Access Compliance Report

Public Rights-of-Way

Intersection ID: 7877	Main Street: PONDELLA_DR	Cross Street: SNOW_WHITE_LN	Location: SE
ADA ID: 419BB202E815	Ramp Type: Perp	Initial Pass/Fail: Fail	Overall Compliance: No
Codes/Mitigation Info/Possible Solution		Field Measurements/Component Compliance	
Severity Score: 21.25

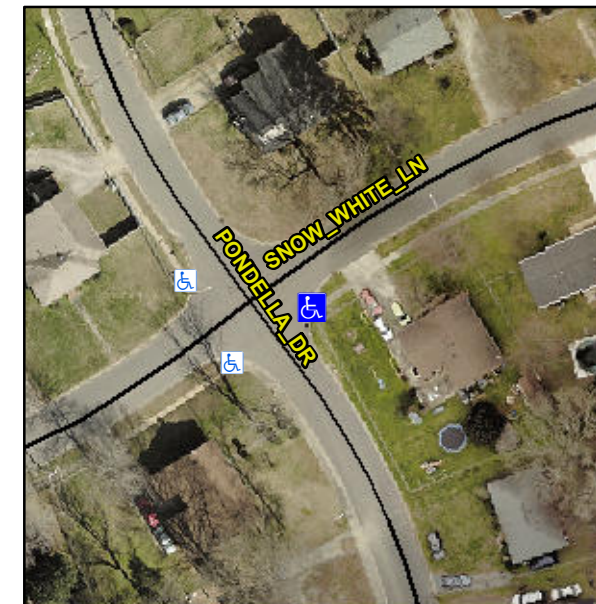
Not Found, R304.5.1, R304.2.2

Compliance	Description	Data	Compliance	Description	Data
N/A	Ramp Length (in)	27.5	No	Ramp Slope (%)	9.2
No	Ramp Width (in)	45.0	Yes	Ramp XSlope (%)	0.8
N/A	Flare Type LT	N/A	N/A	Flare Type RT	N/A
N/A	Flare Slope LT (%)	N/A	N/A	Flare Slope RT (%)	N/A
N/A	Flare Traversable LT?	N/A	N/A	Flare Traversable RT?	N/A
N/A	Landing Length (in)	N/A	N/A	DWS Provided?	N/A
N/A	Landing Width (in)	N/A	N/A	DWS Contrast?	N/A
N/A	Landing Slope (%)	N/A	N/A	DWS Length (in)	N/A
N/A	Landing X Slope (%)	N/A	N/A	DWS Full Width?	N/A
N/A	Landing Curb? (Y/N)	N/A	N/A	DWS Offset (in)	N/A
N/A	Shared Landing?	N/A			
N/A	Gutter Ponding?	N/A	N/A	Gutter Slope (%)	N/A
N/A	Gutter Lip Ht (in)	N/A	N/A	Gutter X Slope (%)	N/A
N/A	Painted X Walk1?	No	N/A	Painted X Walk2?	N/A
	X Walk 1 Direction	To SW		X Walk 2 Direction	N/A
N/A	X Walk 1 Width (in)	N/A	N/A	X Walk 2 Width (in)	N/A
	X Walk 1 Slope (%)	3.6		X Walk 2 Slope (%)	N/A
	X Walk 1 X Slope (%)	3.0		X Walk 2 X Slope (%)	N/A

Remove & Replace Entire Ramp.
